# Freescale Semiconductor Addendum

Document Number: MPC8379ERMAD

# Errata to MPC8379E PowerQUICC II Pro Integrated Host Processor Family Reference Manual, Rev. 1

This errata describes corrections to the MPC8379E PowerQUICC II Pro Integrated Host Processor Family Reference Manual, Revision 1. For convenience, the section number and page number of the errata item in the reference manual are provided. Items in bold are new since the last revision of this document.

Figure 8-16 System External Interrupt Mask Register (SEMSR)

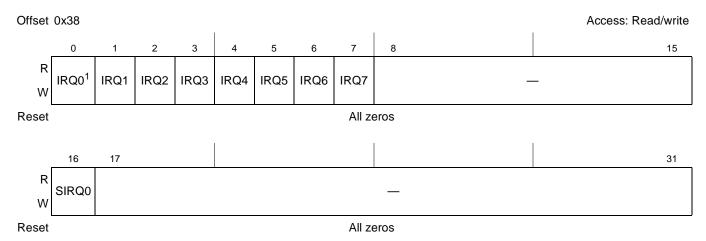
In Figure 8-16, "System External Interrupt Mask Register (SEMSR)," change the following text appearing under the reset values of 0–15 bits from:

"The reset values of implemented bits reflect the values of the external IRQ signals. Reserved bits are zeros."

In addition, delete the second footnote that says:

"The user should drive all IRQ inputs to an inactive state prior to reset negation". The updated figure is shown below:

Figure 10-1 Enhanced Local Bus Controller Block Diagram

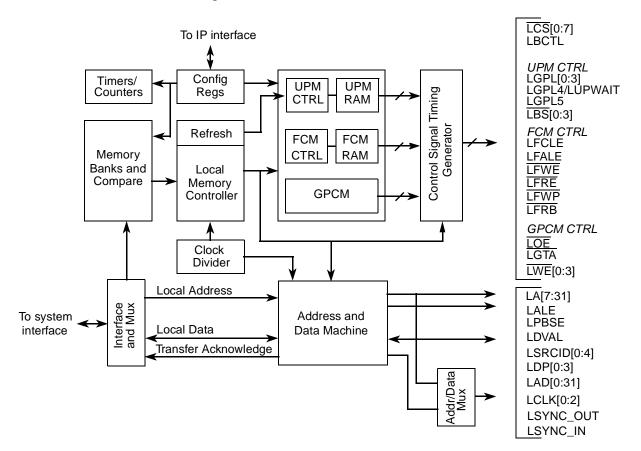
Replace Figure 10-1, "Enhanced Local Bus Controller Block Diagram," with the following:

Figure 10-43. External Termination of GPCM Access (PLL Enabled Mode)

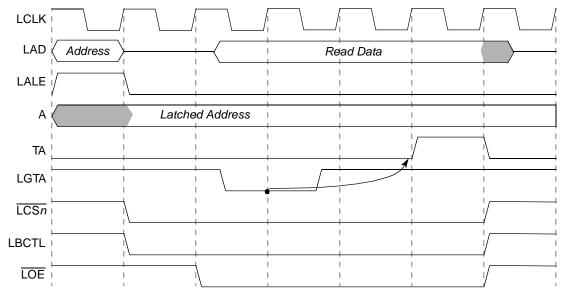
Add an introductory sentence to state that Figure 10-43, "External Termination of GPCM Access," is for PLL-enabled mode as follows:

In PLL-enabled mode, the timing of  $\overline{LGTA}$  is illustrated by the example in Figure 10-43.

Figure 10-44. External Termination of GPCM Access (PLL Bypass Mode)

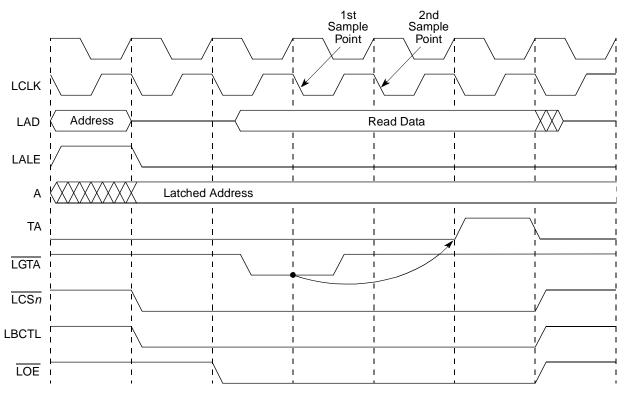
In addition, add a new figure for PLL bypass mode after Figure 10-43 (preceded by an introductory sentence) as follows:

In PLL bypass mode, the timing of  $\overline{LGTA}$  is illustrated by the example in Figure 10-44.

Figure 11-2 eSDHC Block Diagram

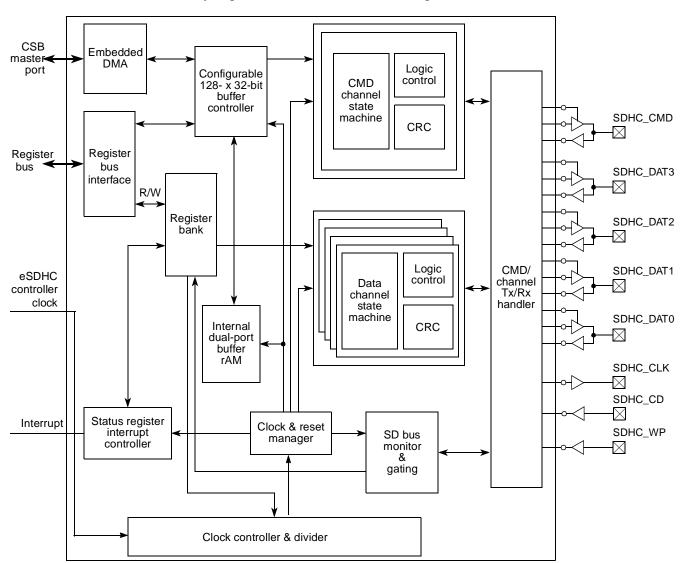
# **11.1, 11-2** Modify Figure 11-2, "eSDHC Block Diagram," as follows:

Figure 11-12 Interrupt Status Register (IRQSTAT)

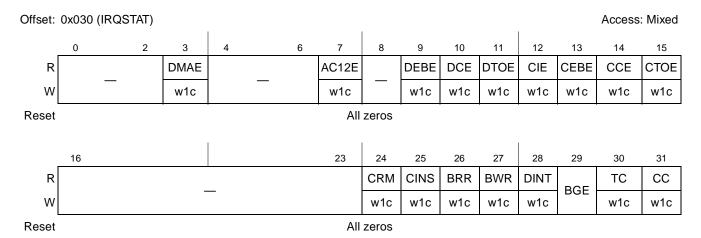
In Figure 11-12, "Interrupt Status Register (IRQSTAT)," change the access information for the BGE bit (bit 29) from "w1c" to "R/W." Also, change the register access from "w1c" to "Mixed." The updated figure is shown below:

Figure 11-12. Interrupt Status Register (IRQSTAT)

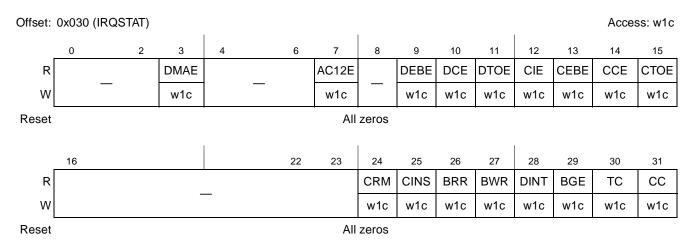
11.4.10, 11-21, 11-23 In Figure 11-12, "Interrupt Status Register (IRQSTAT)," make bit 23 reserved to show as follows:

In addition, remove bit field description of CINT (bit 23) from Table 11-14, "IRQSTAT Field Descriptions," and make it reserved.

Figure 11-14. Interrupt Signal Enable Register (IRQSIGEN)

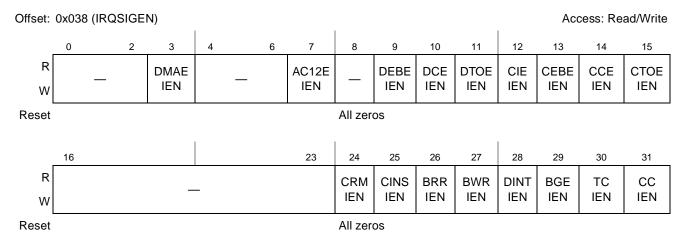
11.4.12, 11-27,11-28 In Figure 11-14, "Interrupt Signal Enable Register (IRQSIGEN)," make bit 23 reserved to show as follows:

In addition, remove bit field description of CINTIEN from Table 11-19, "IRQSIGEN Field Descriptions" and make it reserved.

Figure 11-16. Host Capabilities Register (HOSTCAPBLT)

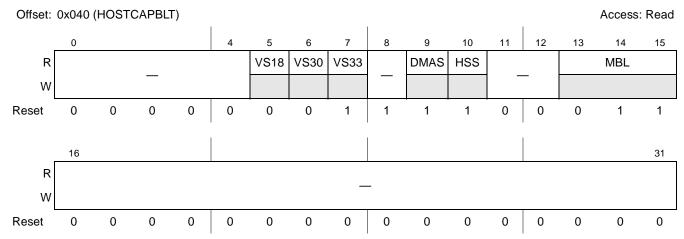
In Figure 11-16, "Host Capabilities Register (HOSTCAPBLT)," make bit 8 reserved to show as follows:

In addition, remove the bit field description of SRS (bit 8) from Table 11-22, "HOSTCAPBLT Field Descriptions," and make it reserved.

Figure 11-18. Force Event Register (FEVT)

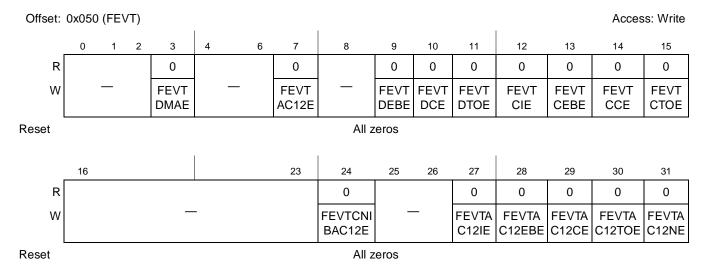
In Figure 11-18, "Force Event Register (FEVT)," make bit 0 reserved to show as follows:

In addition, remove the bit field description of FEVTCINT (bit 0) from Table 11-24, "FEVT Field Descriptions," and make it reserved.

Figure 11-19 Flow Diagram for Card Detection

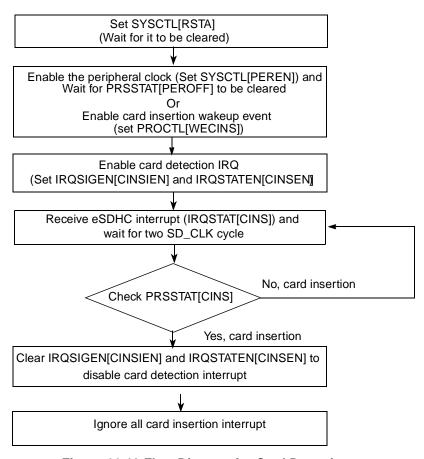
Replace Figure 11-25, "Flow Diagram for Card Detection," and the three bullets after it with the following diagram and steps:

- 1. Set SYSCTL[RSTA] and wait for it to be cleared.
- 2. Set SYSCTL[PEREN] to enable the clocks and wait for PRSSTAT[PEROFF] to be cleared or enable wakeup event (set PROCTL[WECINS]).
- 3. Set IRQSIGEN[CINSIEN] and IRQSTATEN[CINSEN] to enable card detection interrupt.

Figure 17-11 Channel Configuration Register (CCR)

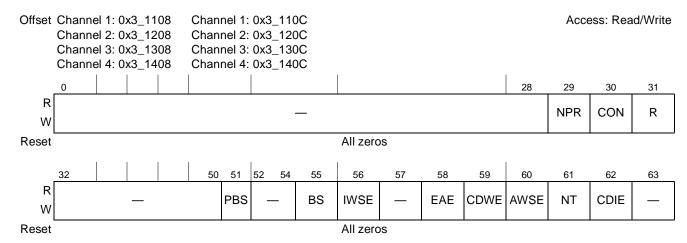
In Figure 17-11, "Channel Configuration Register (CCR)," modify the offsets as shown in the figure below:

Figure 17-12 Channel Status Register (CSR)

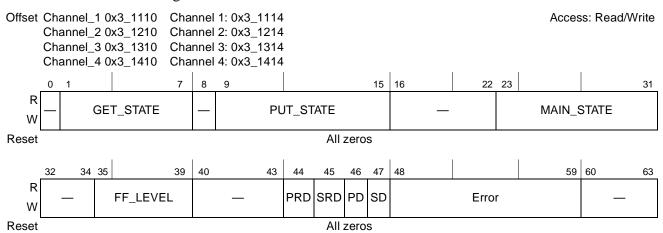
17.4.4.2, 17-41 In Figure 17-12, "Channel Status Register (CSR)," modify the offsets as shown in the figure below:

Figure 18-102. TMR\_CTRL Register Definition

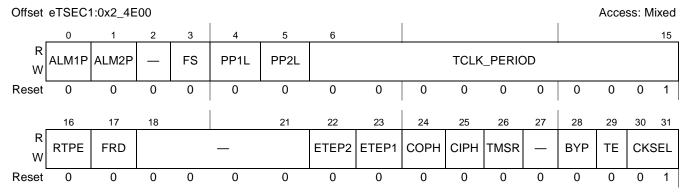
18.5.3.9.1, 18-108 Make bits 20 and 21 as reserved in Figure 18-102, "TMR\_CTRL Register Definition," to show as follows:

Figure 18-128. eTSEC-SGMII Connection

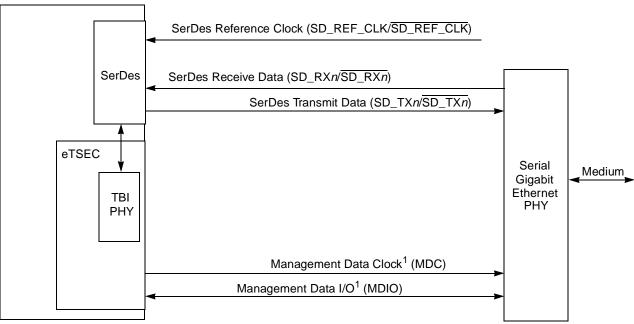
18.6.1.4, 18-135	Add the following section after Section 18.6.1.4, "Reduced Ten-Bit Interface (RTBI)."

Figure 18-137 1588 Current Time Control

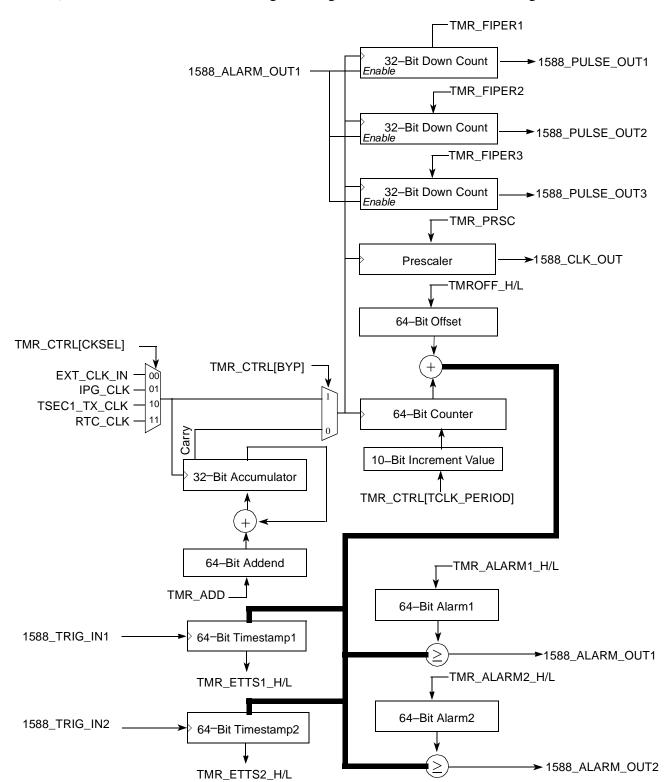
**18.6.5.2, 18-171** Add the following after Figure 18-136, "1588 Timer Design Partition."

Figure 20-54 General Structure of EHCI Periodic Schedule Utilizing Interrupt Spreading

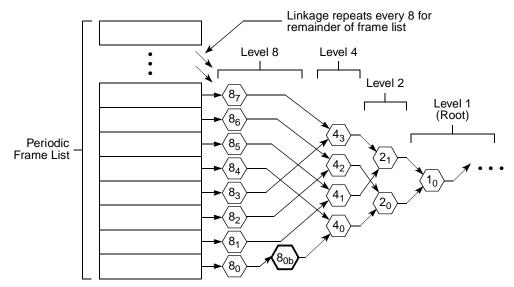
In Figure 20-54, "General Structure of EHCI Periodic Schedule Utilizing Interrupt Spreading" change the notations of the nodes as per the corresponding diagram in "Enhanced Host Controller Interface (EHCI) Specification for Universal Serial Bus, Revision 1.0." The updated figure is shown below:

Figure 20-55 Example Host Controller Traversal of Recovery Path via FSTNs

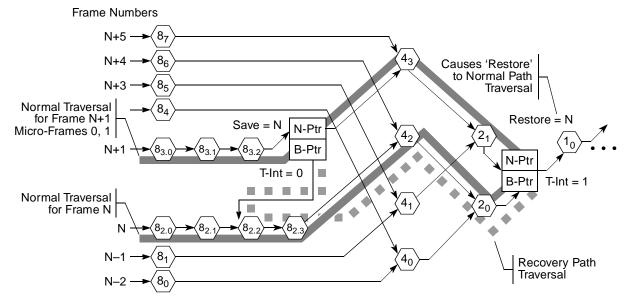
In Figure 20-55, "Example Host Controller Traversal of Recovery Path via FSTNs" change the notations of the nodes as per the corresponding diagram in "Enhanced Host Controller Interface (EHCI) Specification for Universal Serial Bus, Revision 1.0." The updated figure is shown below:

Figure 20-56 Split Transaction State Machine for Interrupt

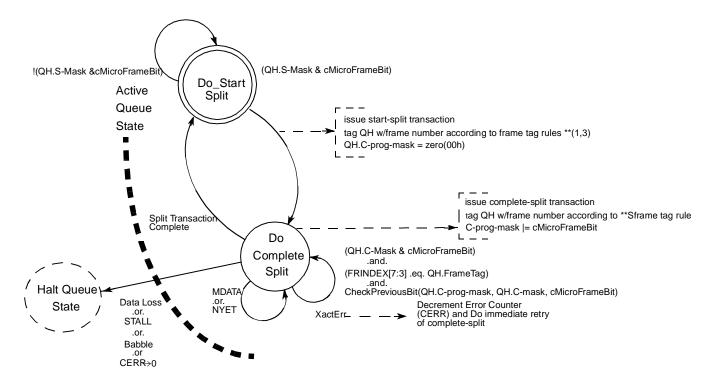
Modify Figure 20-56, "Split Transaction State Machine for Interrupt" as per the corresponding figure given in "Enhanced Host Controller Interface (EHCI) Specification for Universal Serial Bus, Revision 1.0." The updated figure is shown below:

Figure 20-59 Split Transaction State Machine for Isochronous

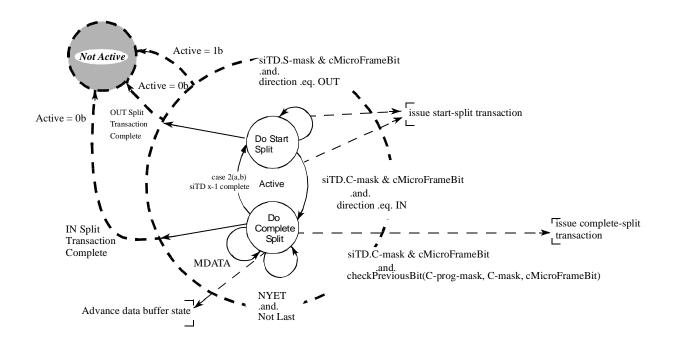
Modify Figure 20-59, "Split Transaction State Machine for Isochronous" as per the corresponding figure given in "Enhanced Host Controller Interface (EHCI) Specification for Universal Serial Bus, Revision 1.0." The updated figure is shown below:

Figure 20-64 Endpoint Queue Head Diagram

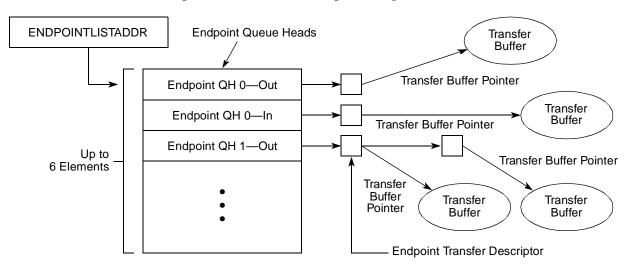
20.8.4, 20-144 In Figure 20-64, "Endpoint Queue Head Diagram," replace "Up to 32 Elements" with "Up to 6 Elements." The updated figure is shown below:
